NO START—VEHICLES WITH 7.3L DIESEL ENGINE	Article No. 00-5-3

FORD: 2000 F-650, F-750

Figure 1 - Article 00-5-3

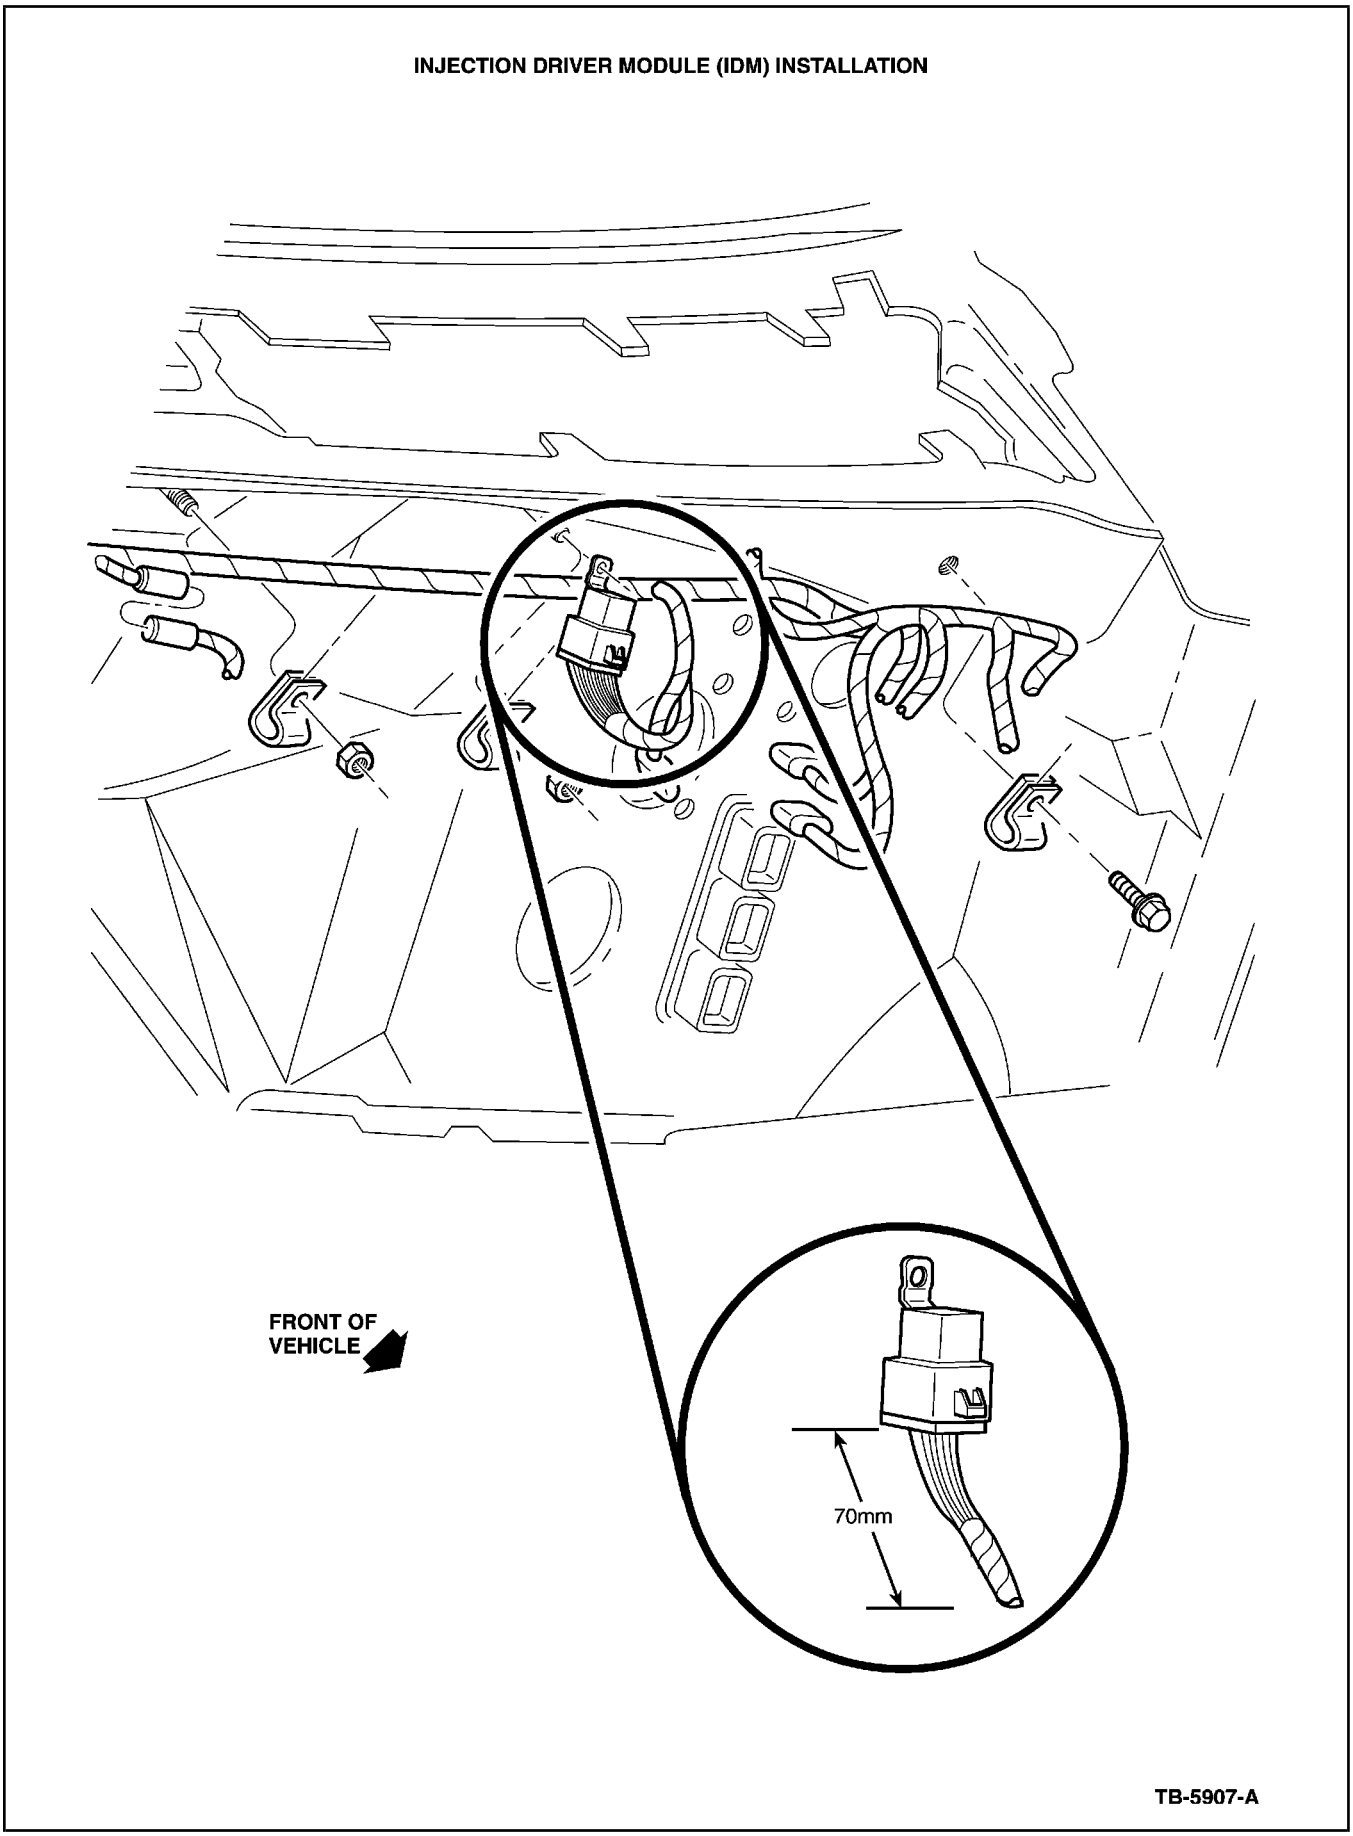
A no start condition may occur on some vehicles. This may be caused by moisture in the Injection Driver Module (IDM) relay main engine wiring harness (-12A581-), which is mounted on the bulkhead.

1. Obtain IDM Service Kit (YC3Z-14303-AA).
2. Cut the takeout to the relay about 70mm after takeout (Figure 1).
3. Shorten the pigtails to the legs that you need and splice to the same colored wire. Refer to TSB 99-22-2 for wire harness terminal repair and wire splice procedure.
4. Remove the IDM relay and install revised IDM relay. If the IDM retainer is broken, tape the new relay on the harness.
